**APPENDIX 26**  
**TRAFFIC NOISE IMPACT ASSESSMENT**

**RE: Response to Comments, Belleayre Resort at Catskill Park, Towns of  
Shandaken and Middletown, Ulster and Delaware Counties, NY; CME  
Project No. 111-164**

**RE: Modified Belleayre Resort at Catskill Park, Towns of Shandaken and  
Middletown, Ulster and Delaware Counties, NY; CME Project No. 111-164**

# NOISE IMPACT ASSESSMENT

NOISE MEASUREMENT/RECEIVER  
 LOCATION PLAN  
 BELLEAYRE RESORT AT CATSKILL PARK  
 TOWNS OF SHANDAKEN AND  
 MIDDLETOWN, NEW YORK

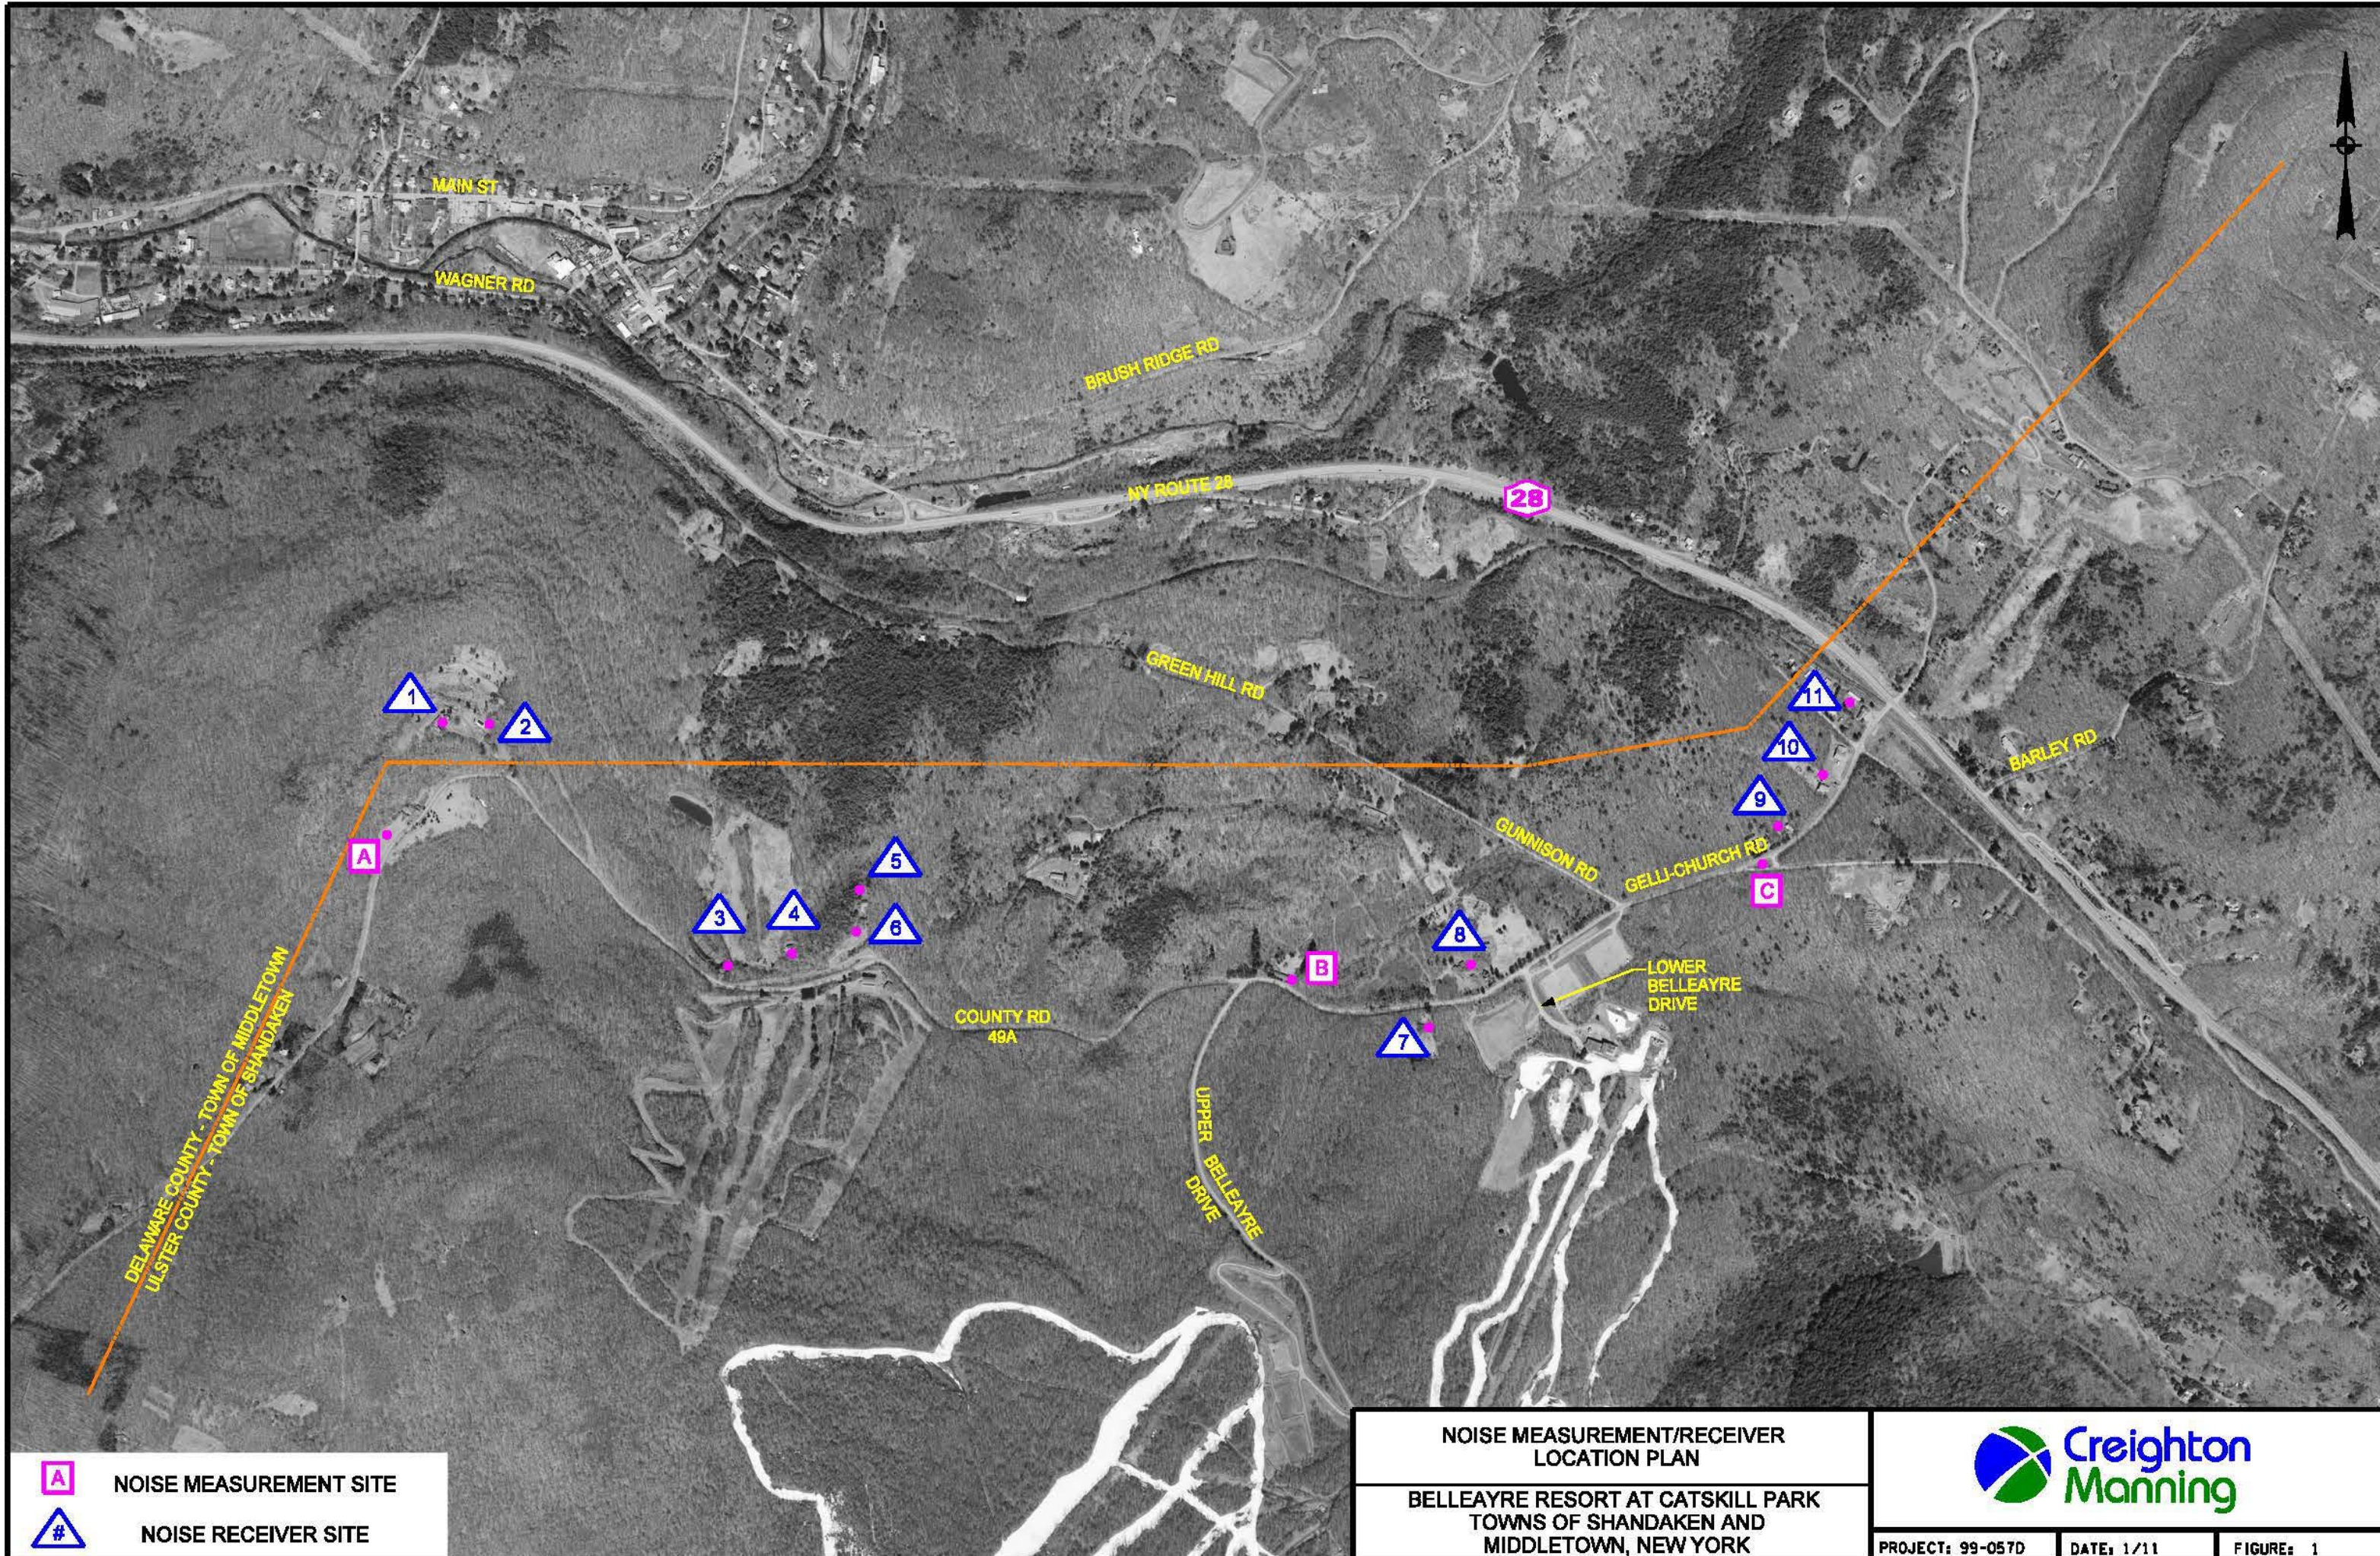
In response to comments from the New York State Department of Environmental Conservation (NYSDEC, page 4 of their June 4, 2012 letter to you), Creighton Manning has conducted ambient noise measurements during summer conditions to supplement the data presented in the *Noise Impact Assessment* prepared for the subject project (Part B SDEIS, Appendix 26). Below is a summary of the supplemental data.

Field measurements were obtained at the three noise measurement sites included in the initial *Noise Impact Assessment* completed for the project (see attached Figure). The measurements were obtained using a Quest Technologies Model 2900 (ANSI Type II) noise level meter. The meter is a battery-powered instrument, which was field tested for proper calibration before and after each measurement. Measurements were taken on Thursday, August 2, 2012 and the weather was partly cloudy with temperatures ranging from low 70's to low 80's throughout the day and wind speeds less than 5 mph. Humidity levels range from approximately 60 to 70% in the morning and 45 to 55% during the afternoon. These meteorological conditions are within the parameters for accurate operation, as recommended by the manufacturer. A minimum of 15-minutes of data was recorded at each site, with the meter paused during each session when vehicles were present during the measurements without traffic.

Measurements were taken at Site A at 9:55 AM, 12:45 PM, and 4:35 PM. The morning and late afternoon measurements were taken to exclude any traffic related noise consistent with the measurements recorded in the initial *Noise Impact Assessment*. The mid-day measurement included traffic related noise, although it is noted that only one vehicle passed by during the measurement. Table 1 summarizes the measurements.

Site A is located near a field where insects were loud during the morning and afternoon measurements resulting in higher ambient noise levels. During the mid-day measurement the insect noise was noticeably quieter which is reflected in the resulting decibel levels, which are comparable to the measurements taken in November when the insect noise was also very low. In general, all of the noise measurement levels are low indicating relatively quiet conditions exist in the study area.

Measurements were taken at Site B at 9:15 AM, 12:11 PM, and 3:54 PM. The morning and late afternoon measurements were taken to exclude any traffic related noise consistent with the measurements recorded in the initial *Noise Impact Assessment*. The mid-day measurement included traffic related noise and included four vehicles passing by the measurement site. Table 2 summarizes the measurements.

Site B is located in a wooded area unlike Site A which is located adjacent to a field where insect noise is more prevalent. During the morning measurement at Site B the noise was mostly related to dew dripping from the trees and some birds chirping. During the mid-day and afternoon measurements the ambient noise levels were

Measurements were taken at Site C at 8:36 AM, 11:39 PM, and 3:18 PM. The morning and late afternoon measurements were taken to exclude any traffic related noise consistent with the measurements recorded in the initial *Noise Impact Assessment*. The mid-day measurement included traffic related noise and included seven vehicles passing by the measurement site. Table 3 summarizes the measurements.

During the morning measurement at Site C, the noise was mostly related to dew dripping from the trees, birds chirping, and distant noise from NY Route 28 traffic. During the mid-day and afternoon measurements the ambient noise levels were increased due to leaves rustling on the trees and some insect noise. Similar to the Site A measurement results, during the measurements when the environmental noises were minimal (mid-day at Site A, morning at Site C) the decibel levels recorded were comparable to the November 2007 measurements. In general, all of the noise measurement levels are low indicating relatively quiet conditions exist in the study area.

The noise measurements obtained at the three measurement locations during August had some results that were consistent with measurements taken in November 2007 and some results that reflected higher ambient noise levels due to active environmental conditions (insects, birds) that were absent in the November measurements. The results obtained at each receiver in August were compared to the modeling results presented in the initial *Noise Impact Assessment* and verified that the results presented in the report show the worst case impacts associated with the development of the site with increases of three dBA or less along CR 49A. In our professional capacity we find that the additional data collected supports the findings of the SDEIS and that our original conclusions regarding traffic noise can be made with reasonable certainty.
